**Implementation Guide for the Common
Electrical Interface (CEI 2.0)**

Title: Implementation Guide for the Common Electrical interface (CEI-2.0)

Date: August 15, 2007

Abstract: This document provides text for proposed corrections, clarifications, and improvements to the Common Electrical Interface (CEI-2.0) Implementation Agreement. It is the product of the CEI maintenance work conducted in the PLL Working group in accordance with maintenance procedures set out in OIF2002.266.00.

Figure 2-37. Cumulative Distribution Function of Maximum Amplitude

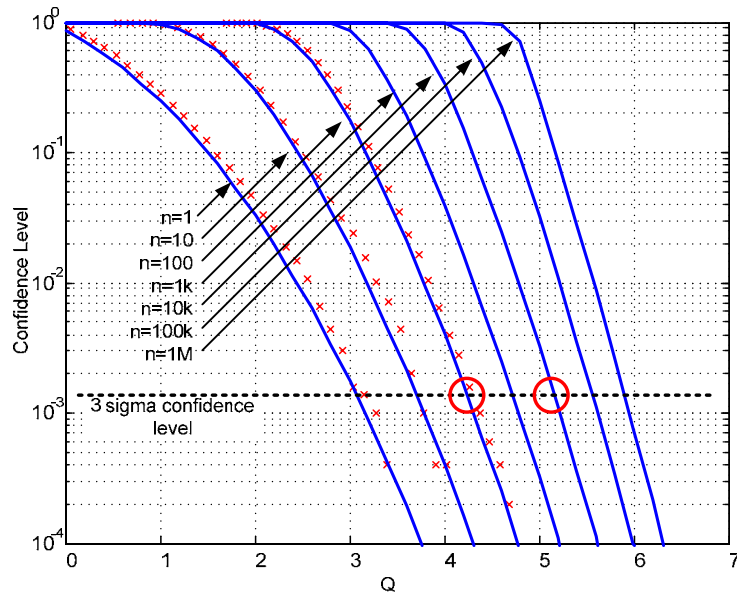
This corrects an error in Figure 2-37 where the "3-sigma confidence level" line was incorrectly placed. The corrected figure appears as below:

Item	Section	Page	Line	Change from	To
1	2.E.3.2	87	18	Replace Figure 2-37 with updated version correcting position of 3 Sigma Confidence Level Line	
2	2.D	70	1	Place the description of CEI Test Patterns contained in Section 5.2 into the CEI Document as "2.D Annex – Definition of CEI Test Patterns" Re-number the existing Sections 2.D and 2.E as 2.E and 2.F respectively.	
3	2.1.1	35	16 - 41	Replace entire Sections "2.x.1 Defined Test Patterns"	"2.x.1 Defined Test Patterns The test pattern to be used for output Jitter and jitter tolerance compliance testing should be chosen for the type of data that the link will carry in accordance with Table 2.1 of Annex 2.D.
	2.2.1	37	14 -19		
	2.3.1	39	8 -14		
	3.4.1	41	8 - 12		
	3.5.1	43	8 - 34		
	2.1.1	35	49	Remove footnotes "All descriptions to PRBS31 imply the standard polynomial as described in [21]"	
	2.2.1	37	49		
	2.3.1	39	49		
	3.4.1	41	49
